ON-SITE WASTEWATER
DISPOSAL SYSTEM

NEWPORT STATE AIRPORT

REDLING ASBUILTS BY
CASSELLA CONSTRUCTION, INC.
3/12/18 (DWG FILE ALSO COMPLETED
WITH SURVEYED ASBUILT LOC. OF PIPES)

SCHEDULE B - WASTEWATER SYSTEM - BID SET

SITE 2 - TEST PIT LOCATION PLAN 2

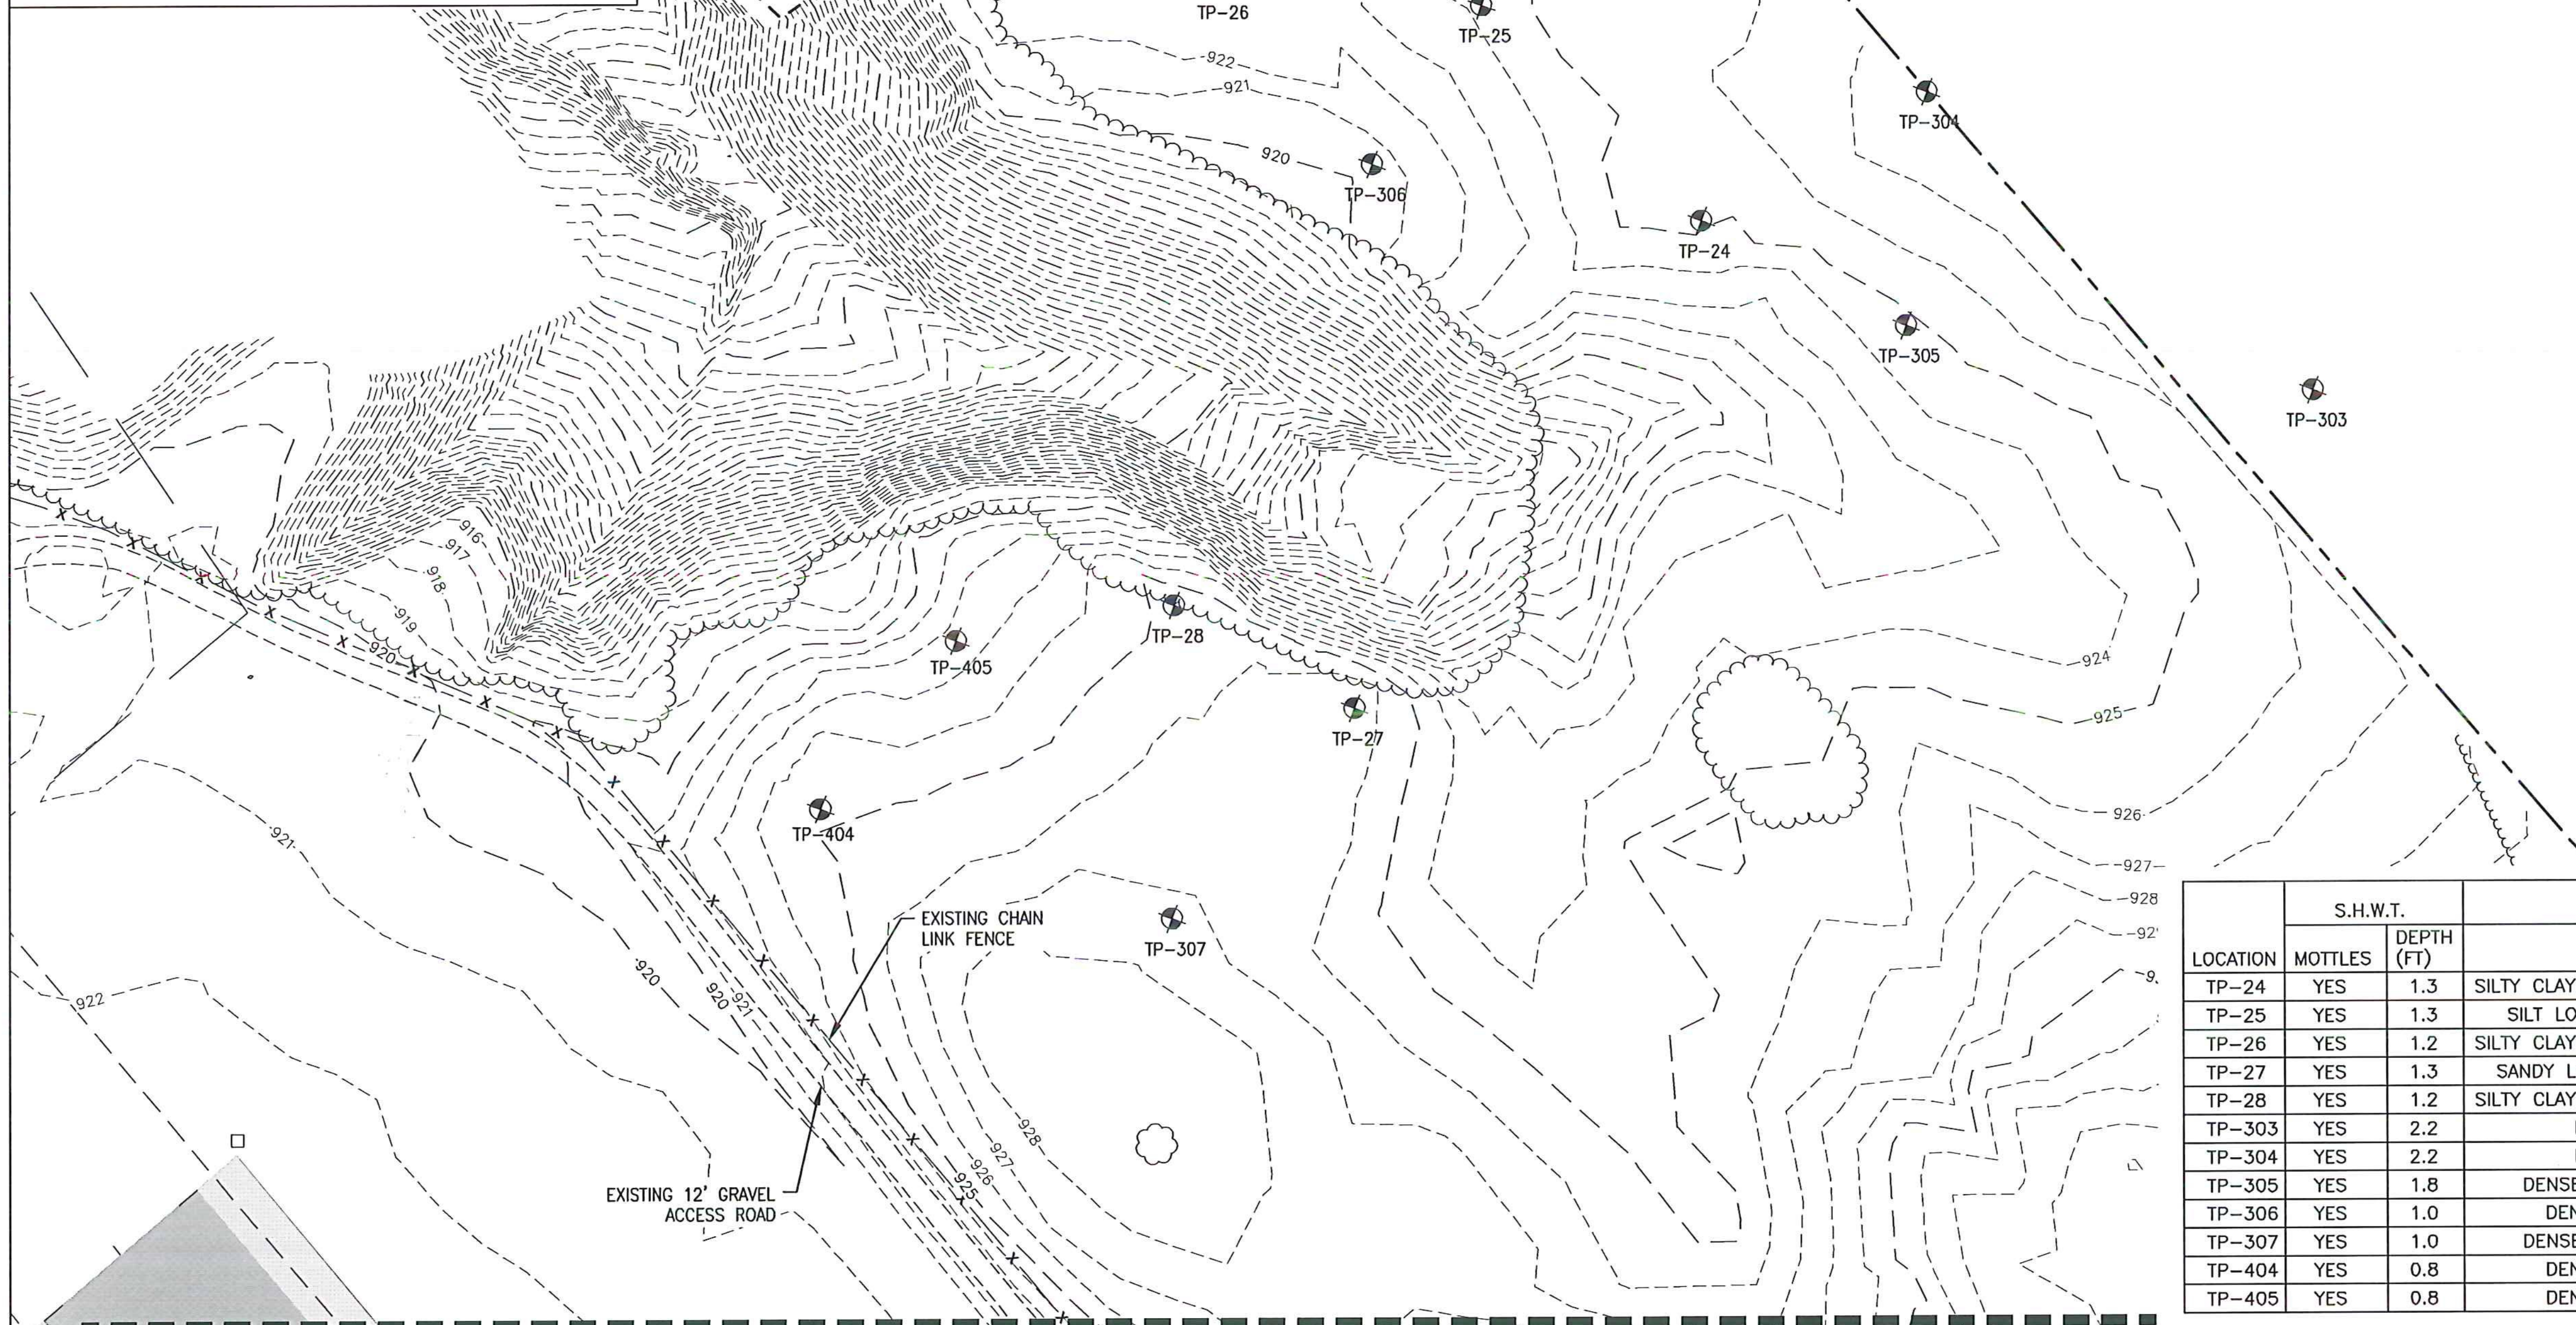
SEE RFI #3 FOR EX. TOPSOIL THK.

NEWPORT STATE AIRPORT COVENTRY, VERMONT NEWPORT WASTEWATER		
SITE 2 - MOUND E DETAIL		
SCALE: 1" = 20'	DESIGN: TCB	MD2-02 29 of 96
DRAWN: TCB	PROJECT: 17958.01	
CHECKED: BLS	DATE: JUNE, 2014

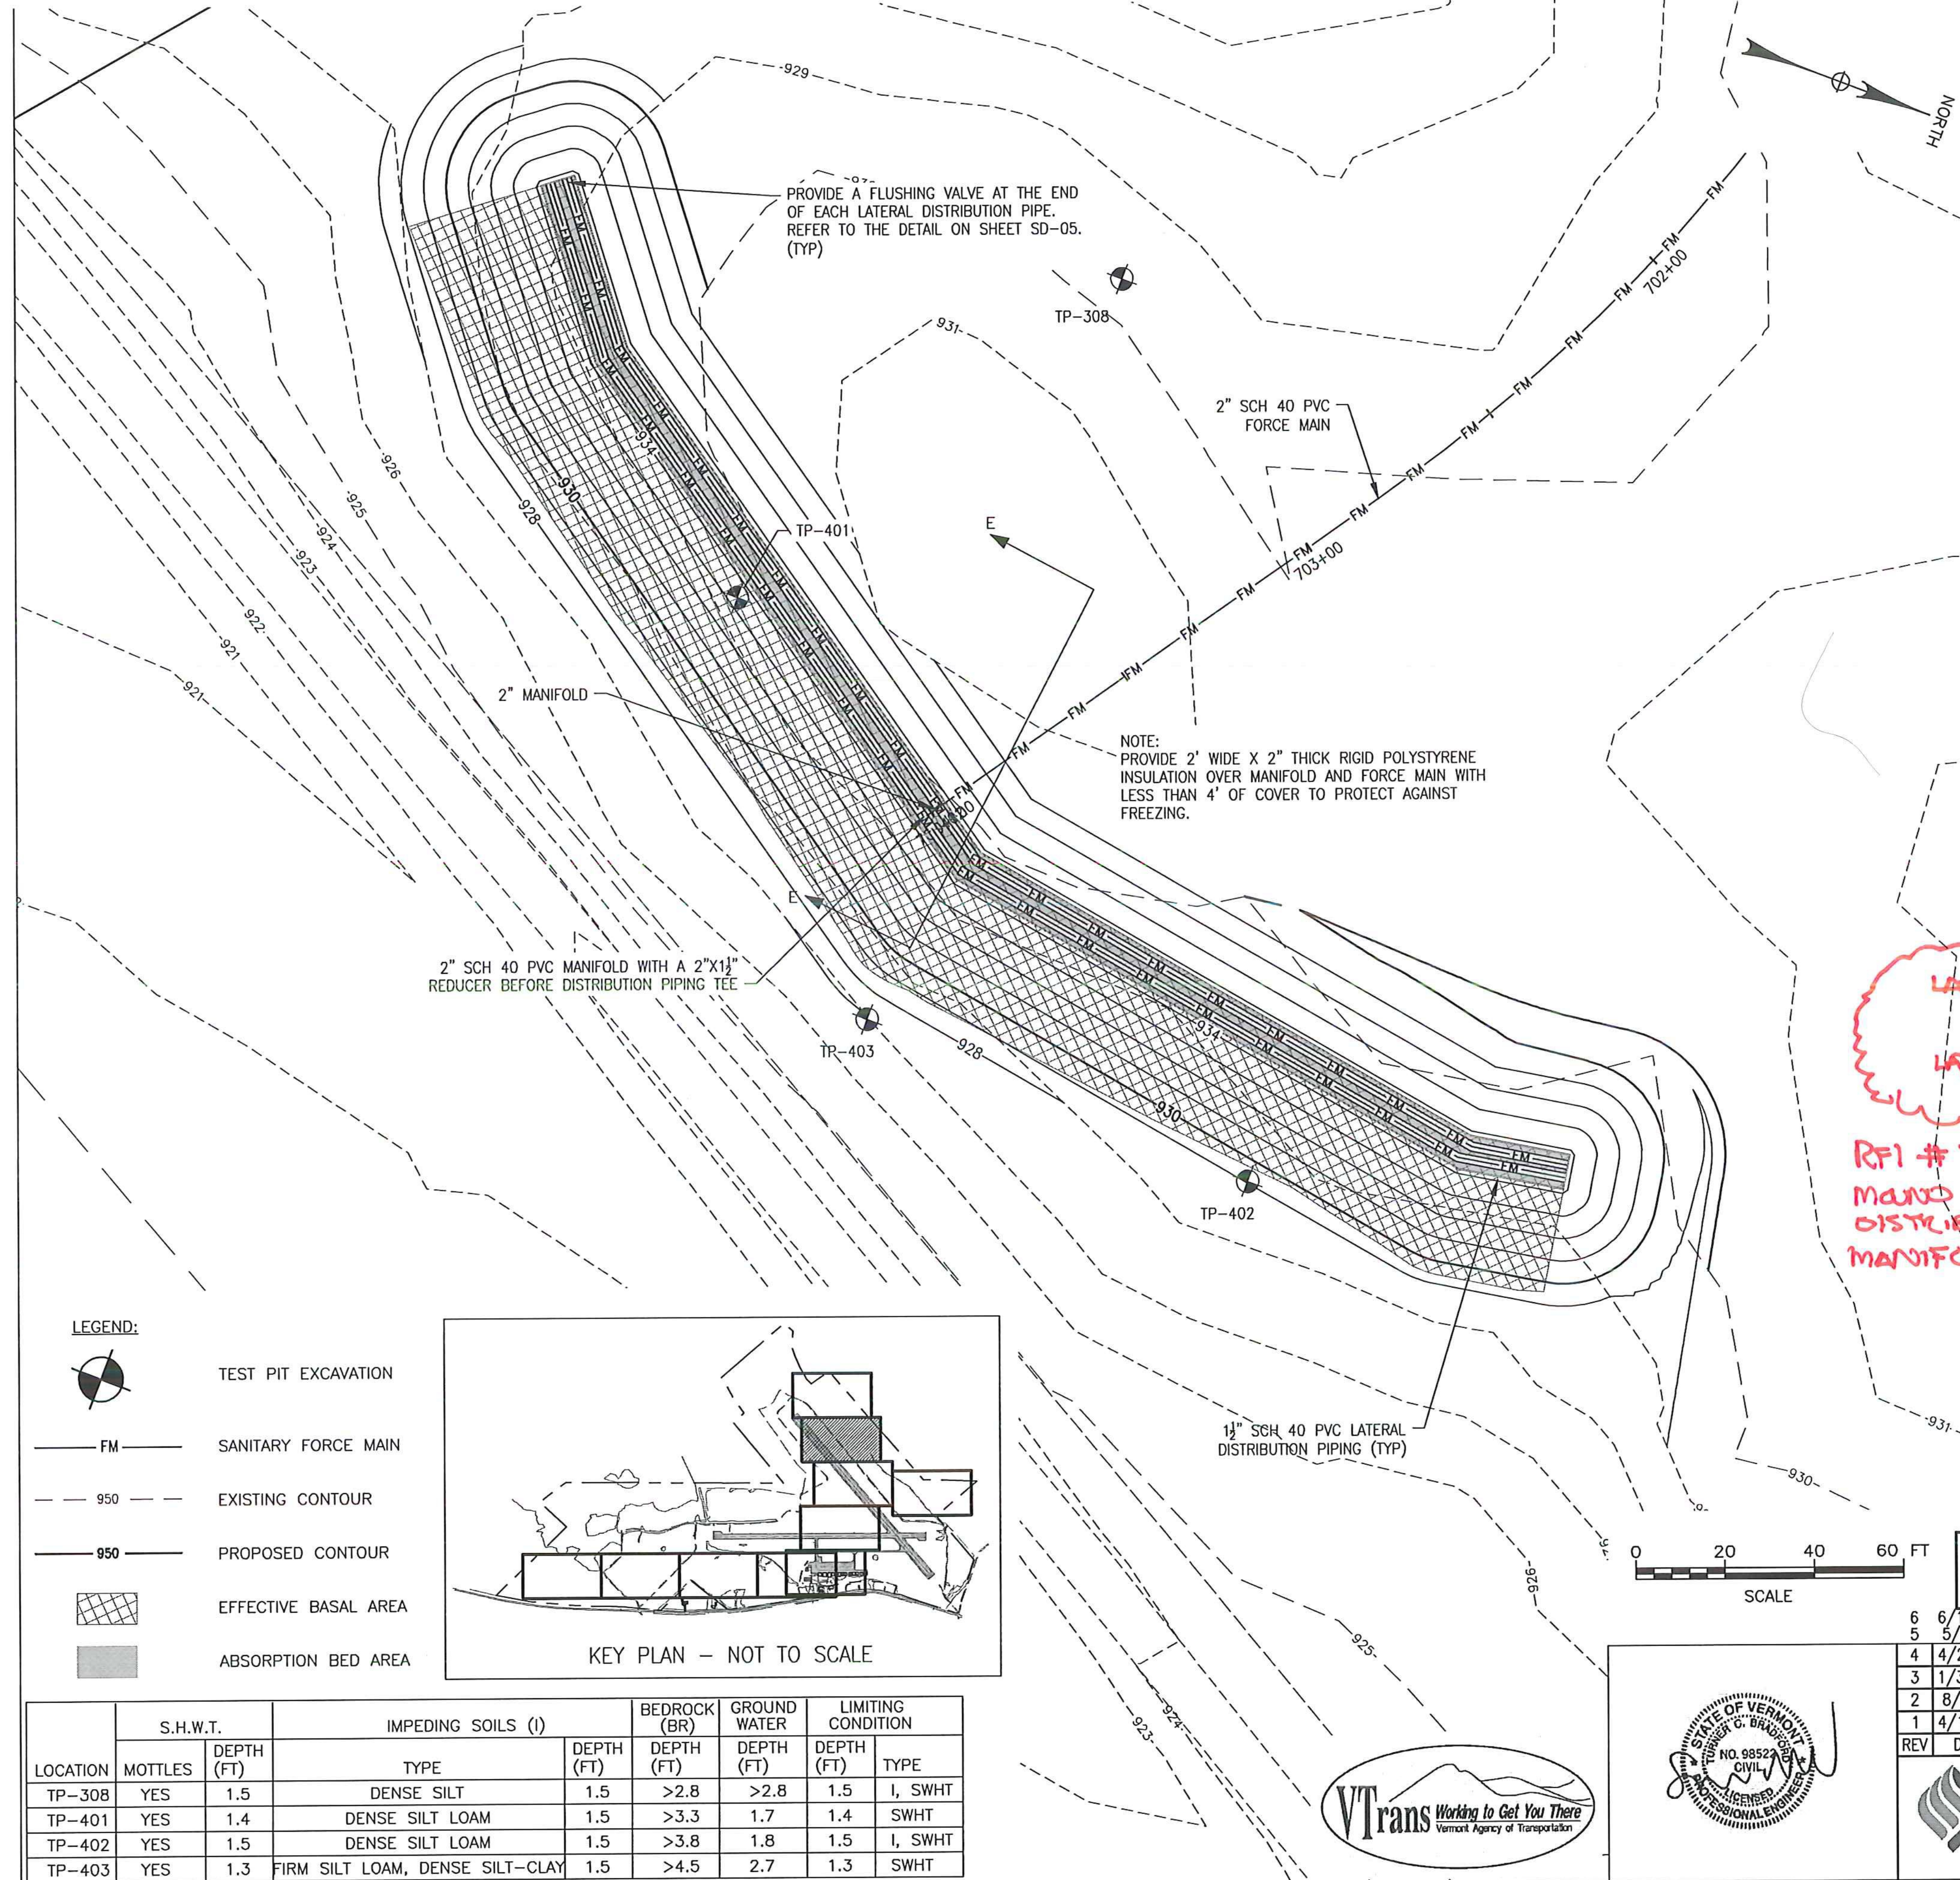
*RFI #7  
 MANIFOLD DISTRIBUTION  
 MANIFOLD*

*RFI #3  
 EX. TOPSOIL THK.  
 RFI #6 NO CHANGE  
 TO GRADES*

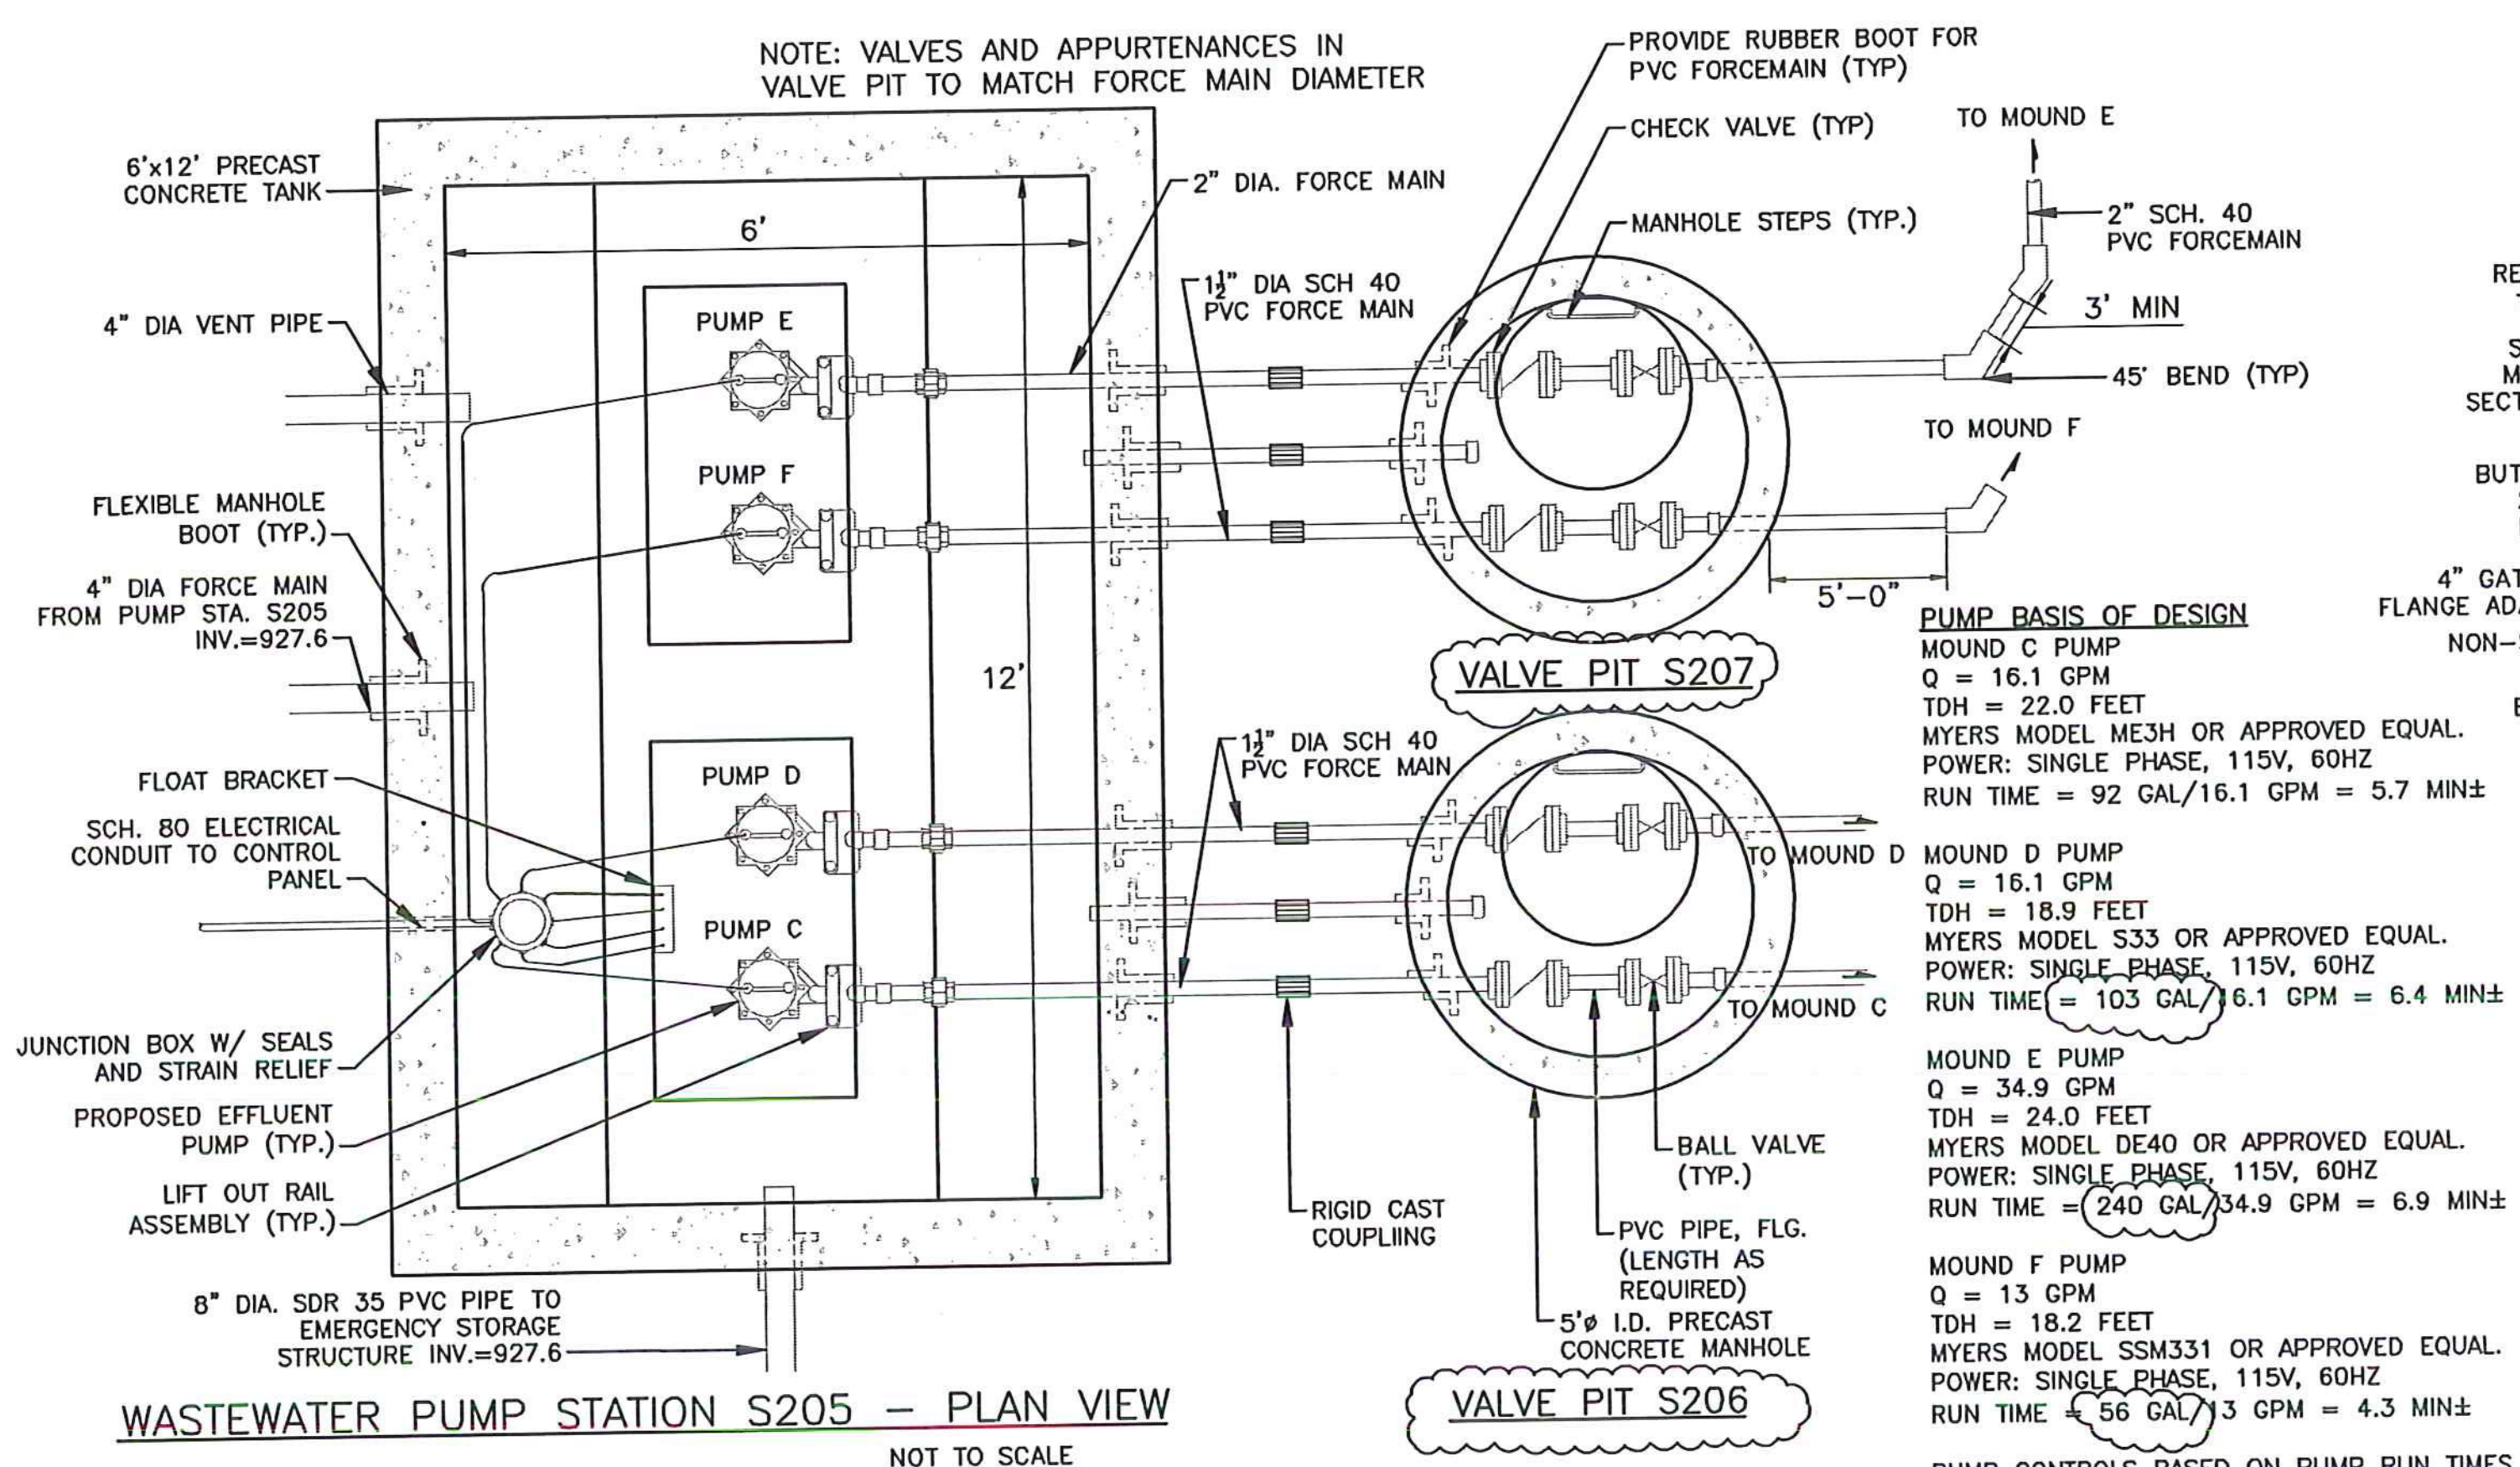
SEE RFI #4 FOR BALANCE CALCS.
